The Commission has issued the enclosed Amendments No. 22 to Facility Licenses Nos. DPR-32 and DPR-37 for the Surry Power Station, Units 1 and 2. The amendments consist of changes to your Technical Specifications for each license and are in response to your request dated April 19, 1976.

The amendments revise the provisions of Section 6.0 of the Technical Specifications related to reorganization of the Chemistry and Health Physics groups.

SURRY POWER STATION UNIT NO. 1

Amendment No. 22
License No. DPR-32

VIRGINIA ELECTRIC AND POWER COMPANY
 SURRY POWER STATION
 ORGANIZATION CHART

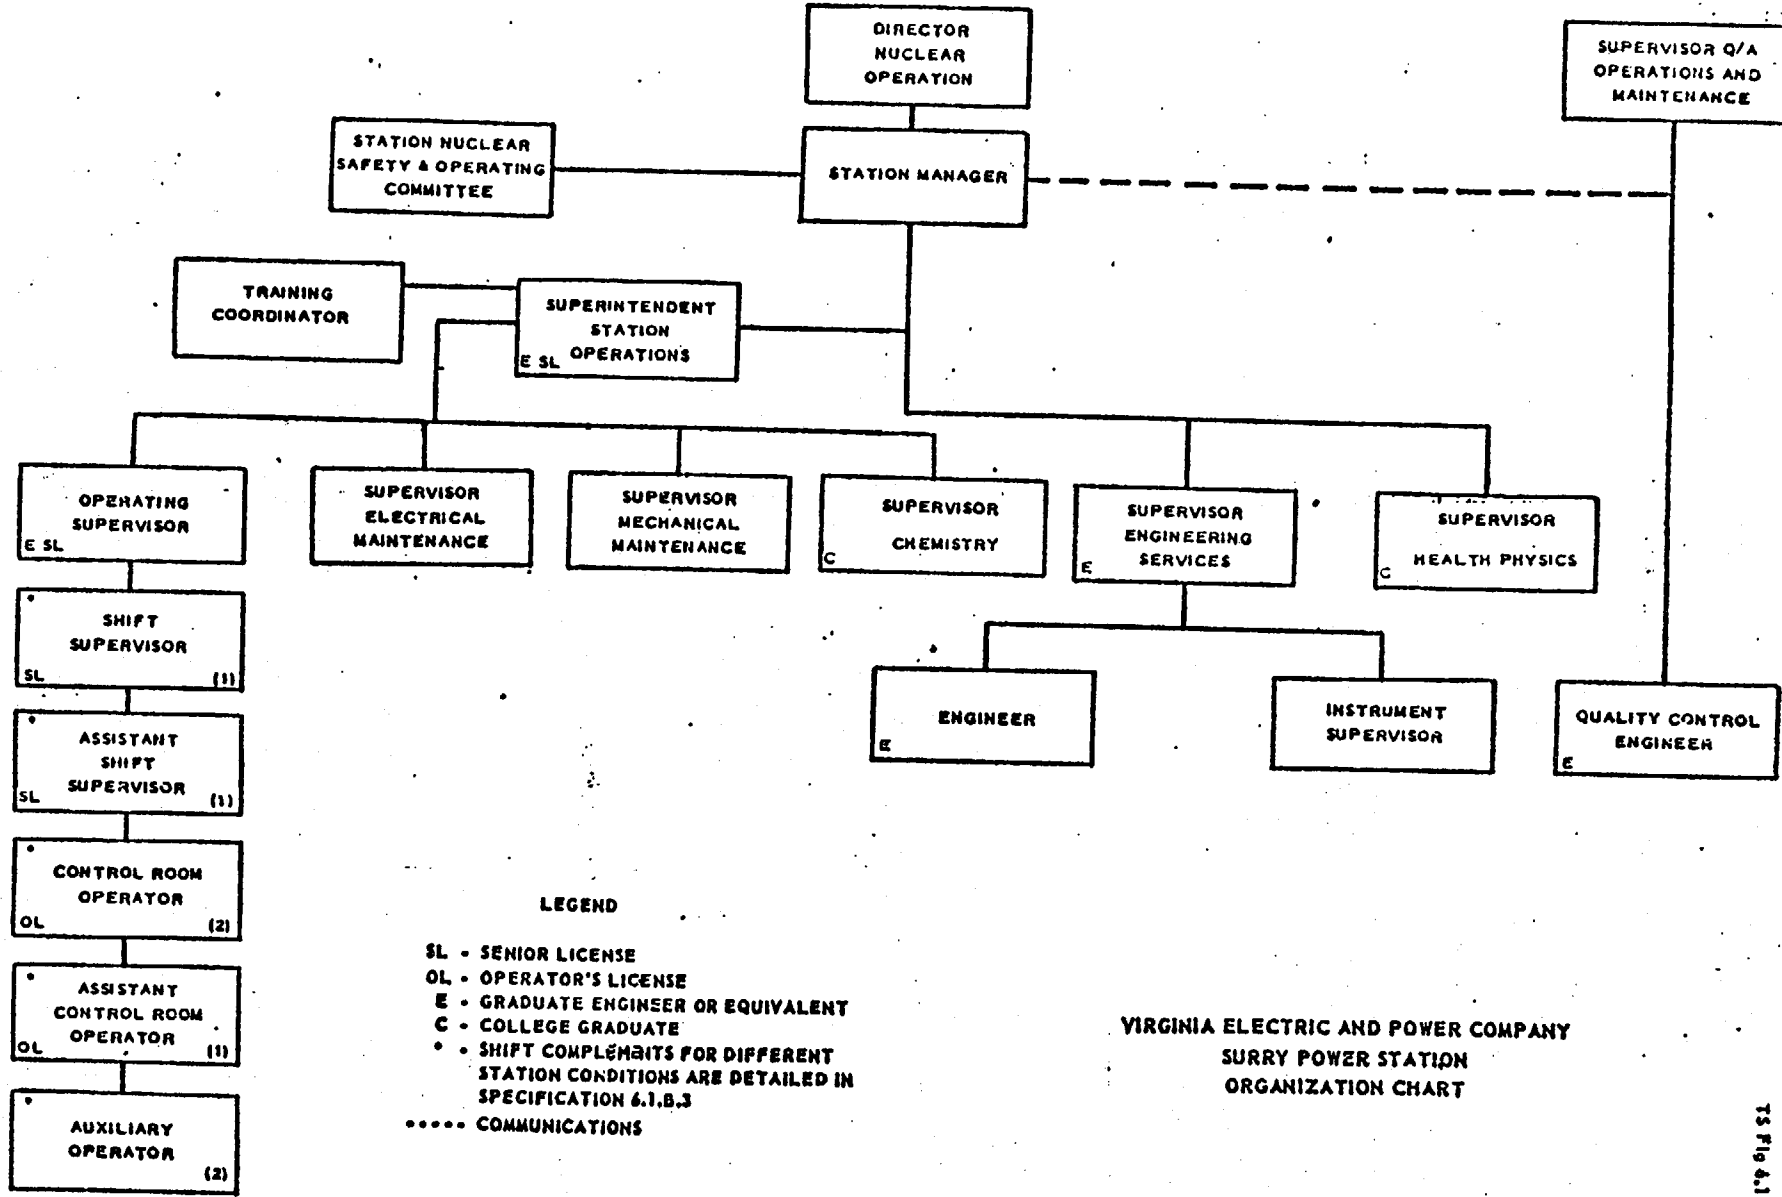
Replace pages TS6.1-1, TS6.1-3, TS Fig. 6.1-3, TS 6.4-2, TS6.4-7a and TS 6.4-7b with the attached pages bearing the same numbers. Changes on these pages are shown by marginal lines.

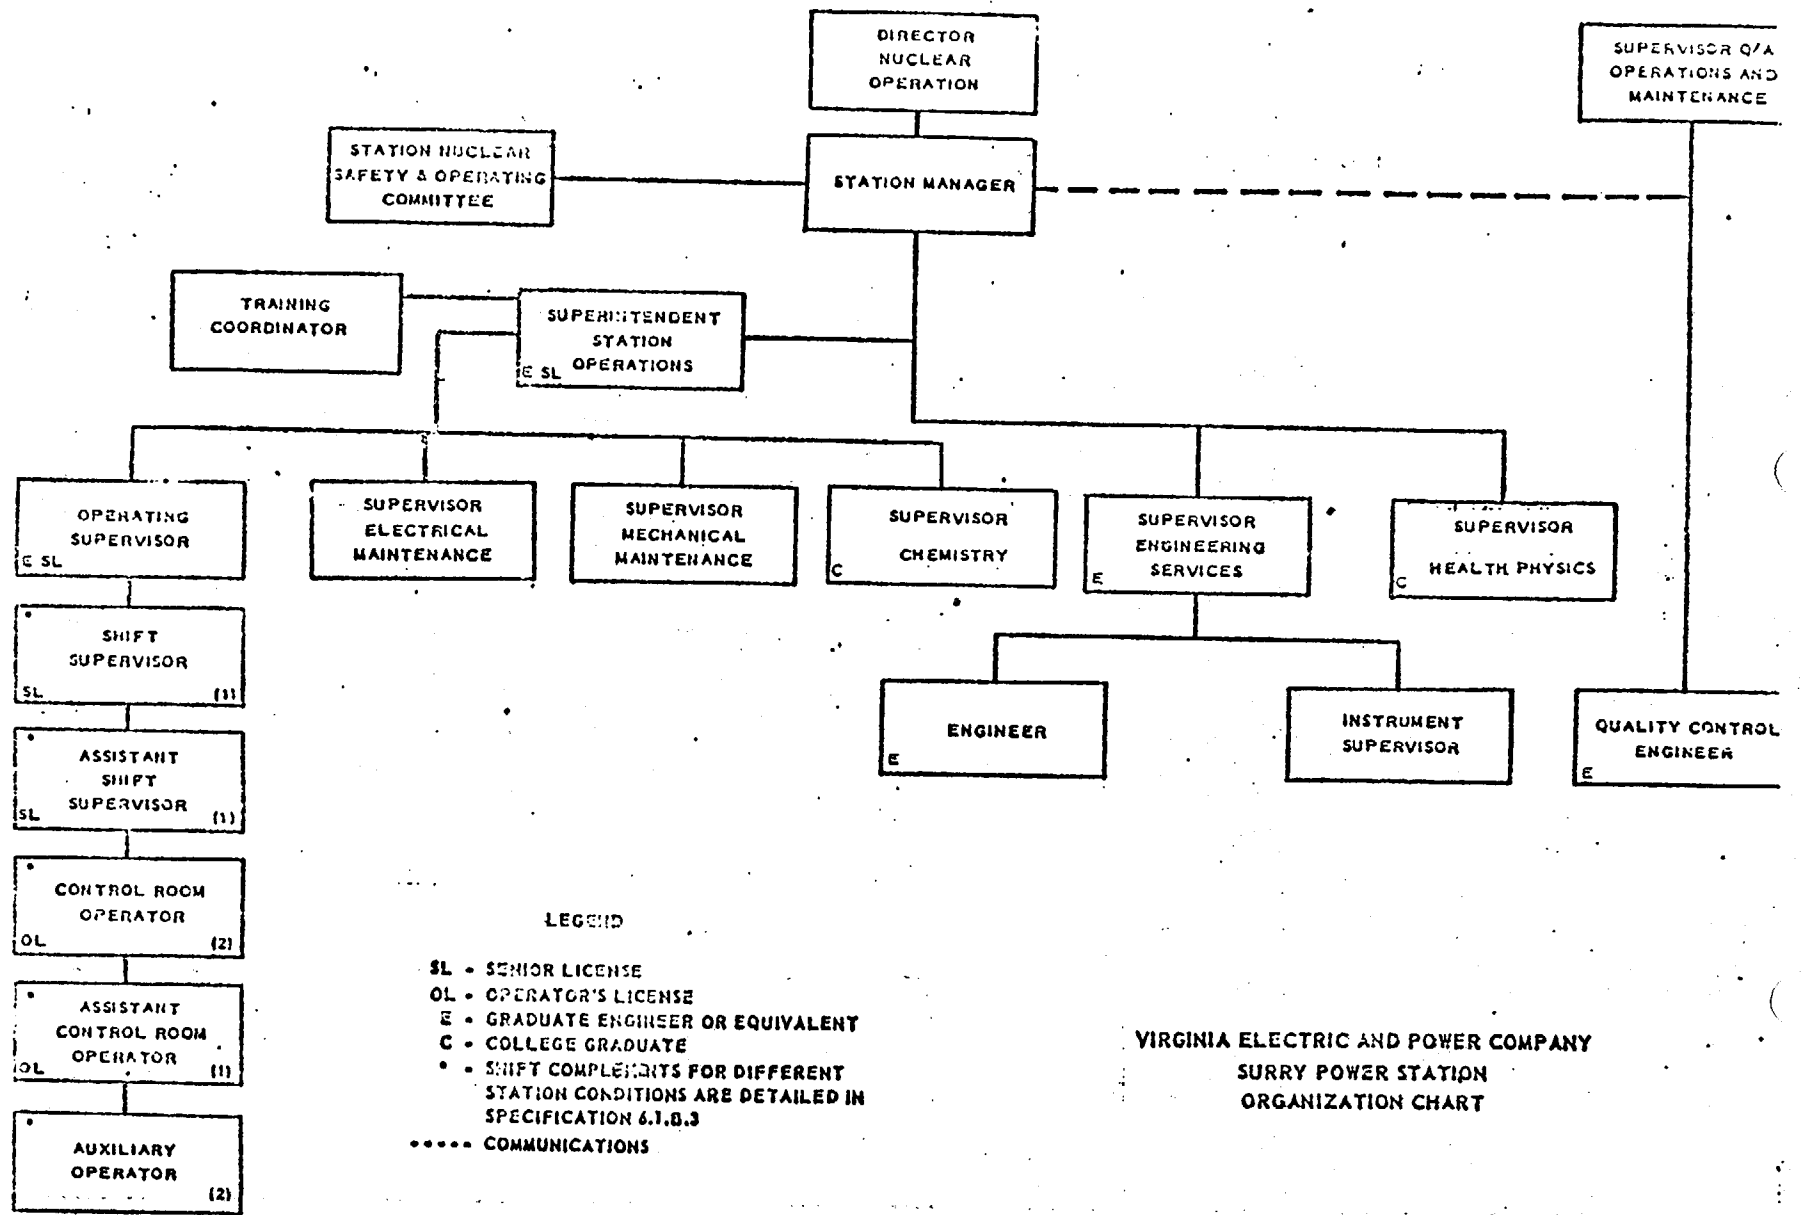
Replace pages TS6.1-1, TS6.1-3, TS Fig. 6.1-3, TS6.4-2, TS6.4-7a and TS6.4-7b with the attached pages bearing the same numbers. Changes on these pages are shown by marginal lines.
